SERVICE PROCEDURE

22524 / 22541
JANUARY, 2023

SUBJECT: SAFETY RECALL 22524 Variation 22541
Hex Flange Lock Nut on certain International® MV™
Series trucks built 01/21/2022 thru 07/26/2022.

Figure 1. Typical Steer Axle Shackle

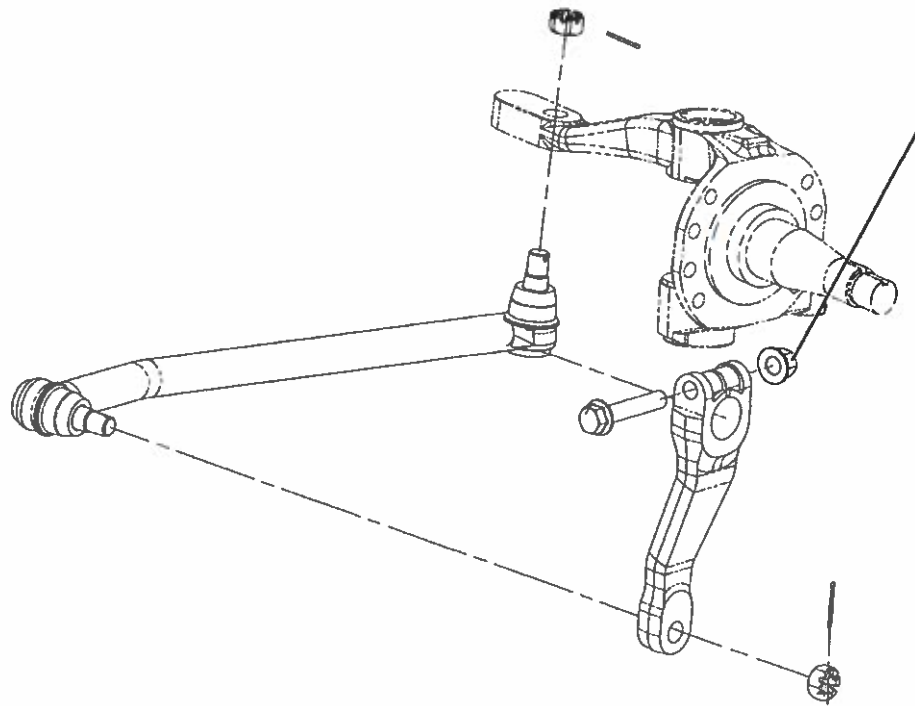
7. Access nuts (Figure 1, Item 1) securing the front steer axle shackle.

8. Remove and replace nuts (Figure 1, Item 1). Using a torque wrench, tighten nuts to 330-370 lb-ft (450-500 N·m).
9. Repeat Steps 7 and 8 for opposite side.

Figure 2. TRW Pitman Arm Nut

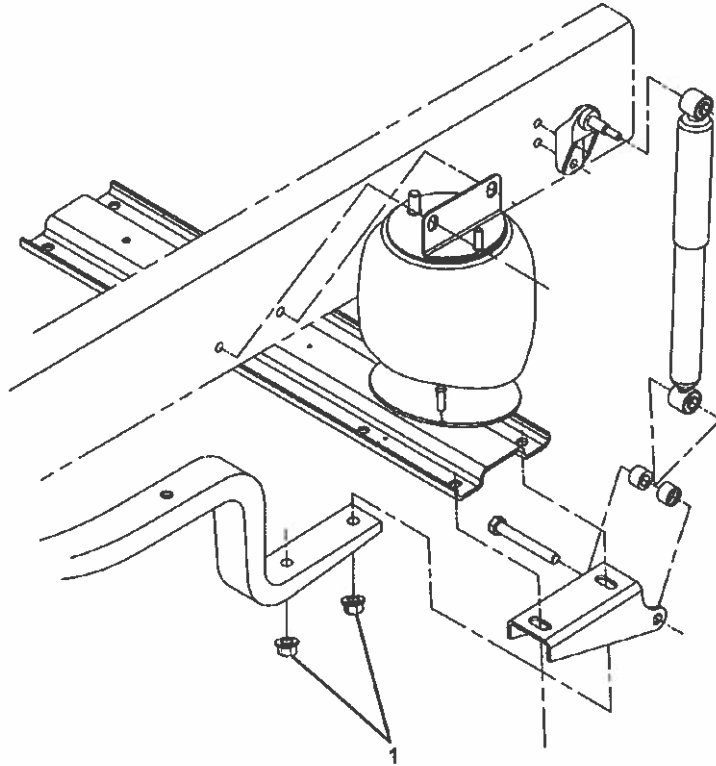
10. Access Pitman arm nut (Figure 2, Item 1).

11. Remove and replace nut. Using a torque wrench and backup wrench positioned on bolt, tighten nut to 330-370 lb-ft (450-500 N·m).
12. Raise vehicle, remove front axle jack stands, and lower vehicle.
13. Using jack, raise rear axles and support vehicle on jack stands.
